CITY OF MELROSE

PLANNING BOARD

Re: Case 24-004, 9 Park Street

CASE INFORMATION

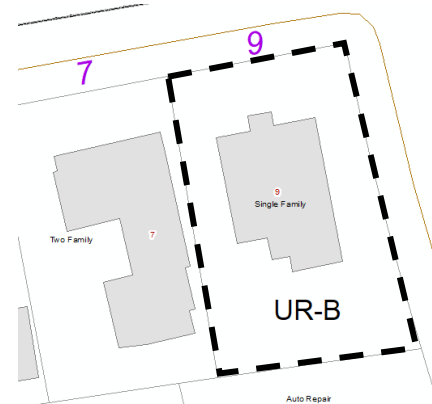
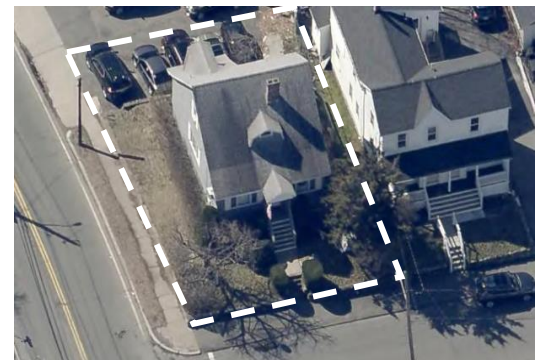
STAFF REVIEW based upon a technical analysis prior to the public hearing
The Applicant began construction on the proposed driveway and has removed the stone retaining wall along the front yard on the right and the existing vegetation, including a mature tree, as shown in the photograph below. Allowing the construction of a driveway in the front yard will be detrimental to the streetscape and is unnecessary given the abundance of parking on the property off Lebanon Street. Additionally, Park Street pitches down towards Linwood Avenue and adding more impervious surface to the front yard will increase the amount of runoff. Staff does not support the variances needed to construct an additional driveway on this property and recommends that the Applicant return the front yard to its original condition and replant the vegetation that was removed.
